MFN 08-076

Docket No. 52-010

Subject: **Response to Portion of NRC Request for Additional
Information Letter No. 117 Related to ESBWR Design
Certification Application - Site Characteristics - RAI Numbers
2.3-4 S03 and 2.3-12**

**Response to Portion of NRC Request for
Additional Information Letter No. 117
Related to ESBWR Design Certification Application
Site Characteristics
RAI Number 2.3-4 S03¹ and 2.3-12**

Figure 2.3-4(1) Typical Sketch of Roof Drain

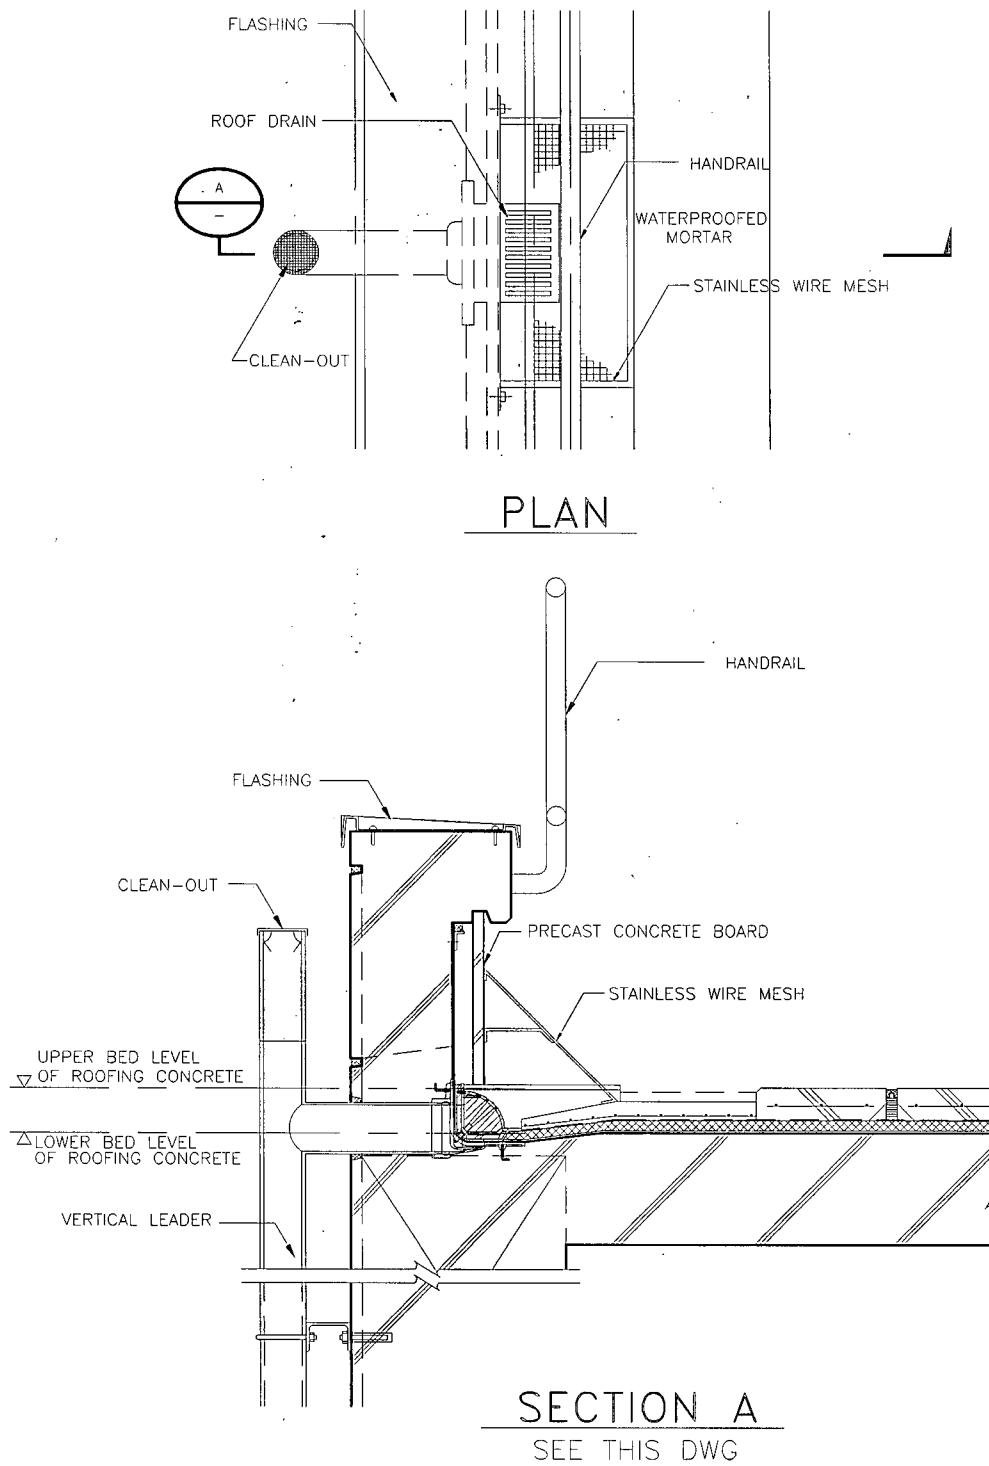
Footnote 5 to DCD Tier 2 Table 2.0-1 states that the roof scuppers and drains are designed independently to limit water accumulation on the roof to no more than 100 mm (4 in) during PMWP conditions. Please provide details of the design of the roof scuppers and drains demonstrating that an antecedent 100-year recurrence interval ground level snow pack of 2394 Pa (50 lbf/ft²) will not clog both the roof scuppers and drains and prevent no more than 100 mm (4 in) of water accumulating on the roof.

In the ESBWR Standard Plant, roofs are provided with two independent drainage systems. The roof drains form the primary drainage system and the scuppers form the secondary drainage system. As required by the International Plumbing Code (invoked by IBC-2003) and ASCE 7-02, only the blockage of the primary system is postulated when designing the secondary system and for calculating the rain load on the roof.

Figures 2.3-4(1) and (2) show typical sketches of the roof drain and overflow scupper. The design of the roof scuppers and drains follows ASCE 7-02. The elevation of the overflow scupper is set such that the average water depth does not exceed 100 mm (4 in.) in case the roof drains are clogged by snow, ice, or other obstructions.
